**HISTORIC LANDMARK COMMISSION**  
**APPLICATION FOR A CERTIFICATE OF APPROPRIATENESS**  
**APRIL 27, 2020**  
**C14H-1978-0033**  
**LITTLEFIELD BUILDING**  
**106 E. 6<sup>TH</sup> STREET**

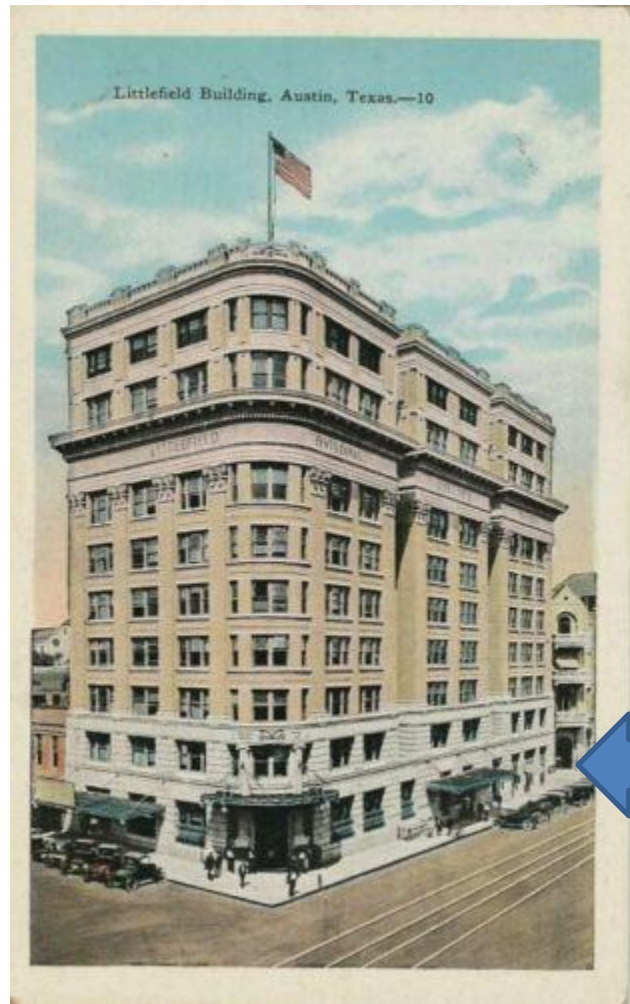
There is currently a metal canopy over the 6<sup>th</sup> Street entrance to the building, but canvas awnings over the retail space to the east. Historic photos show the metal awning and the entry on 6<sup>th</sup> Street but nothing over the current retail space to the east:

Evaluation: There is no historic record of a metal canopy at this location on the building.

Evaluation: If permitted, the new canopy will not mimic the historic style of the existing canopy over the 6<sup>th</sup> Street entrance (which is a modern reconstruction of the historic canopy), but will be compatible with the scale and materials of the existing canopies.

Evaluation: The canopy is designed to be removable; so long as any bolts necessary to secure the canopy to the building are inserted into mortar rather than masonry, the proposed canopy, if permitted, will not damage the building or its essential form and integrity.

The project meets the technical standards for installation and design, but does NOT meet the standard for evaluating the appropriateness of a new metal canopy at this location on the building.

Staff must recommend against this application and recommends that the applicant consider canvas awnings over the windows, as has been previously approved by the Commission and existing on the building now. Historically, the metal awnings on the building were to shelter the main entrances to the building. Construction of a new awning at a location not historically sheltered by one is incongruous with the context of the building and canvas awnings are a more appropriate choice to provide shade to the windows and a backdrop for signage.
